Title: Calidus mast bracket replacement		
AG-SB-2022-01-C-EN	Effective Date: 05 APR 2022	Compliance Category:
Applicability		A - MANDATORY B - RECOMMENDED C - OPTIONAL
Aircraft type & model: Calidus	Affected Serial number(s): All; aftermarket repair	
The maintenance manual to be referenced is this stated or subsequent issue.		As per AutoGyro website
<p>This form is the response from AutoGyro GmbH either against a problem found in the product in service requiring a containment or rectification action, or as service information for aircraft modification incorporation. For help, contact airworthiness@auto-gyro.com.</p>

Reason and overview of the Service Bulletin (cause of problem if known)

Solidworks view of the improved attachment between the mast and body.

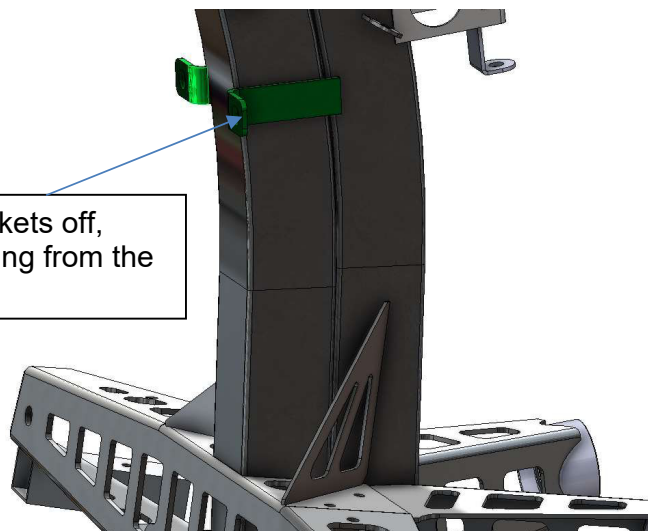
In response to occasional reports of both a crack in the upper mast to body mounting bracket or forward mast in the same area, AutoGyro has developed a repair method to replace the upper mast to body mounting bracket with a separate bracket. This allows mast flexure whilst still providing a secure fixing to the front body. This also allows easy repair without welding, or in-service upgrade.

Pic. 1

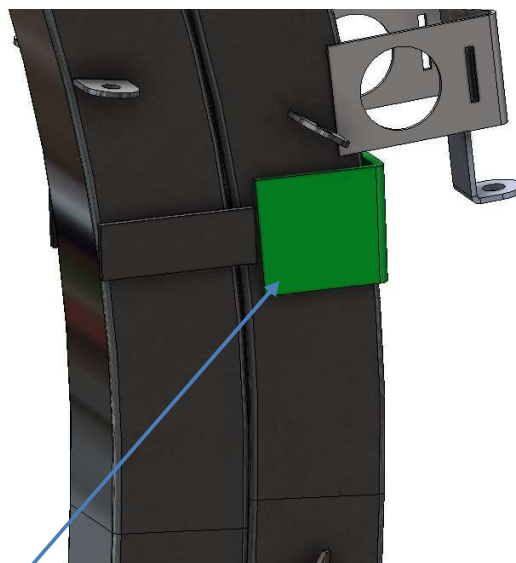
Cut the ears of the brackets off, flush or to 1mm protruding from the mast. Deburr.

Pic. 2

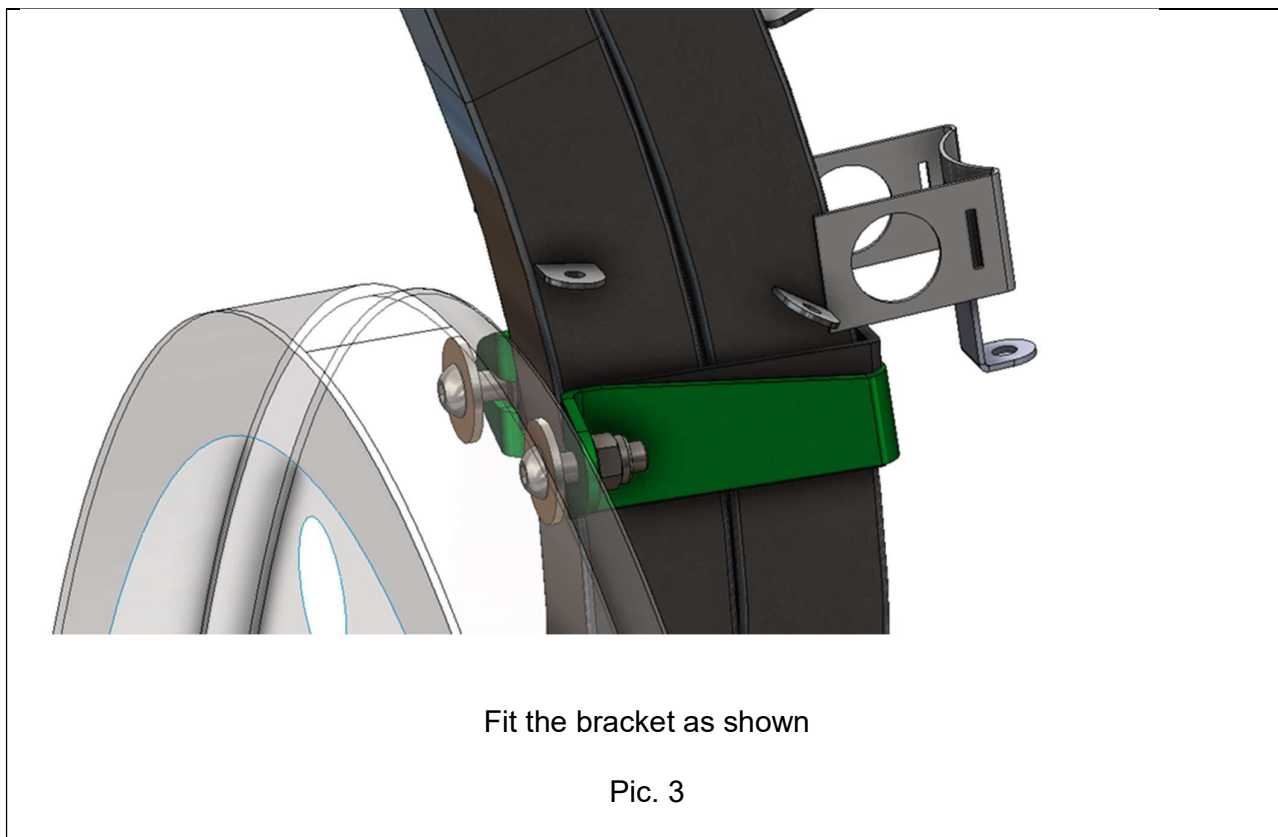
Affix the rubber pad to the mast as shown.
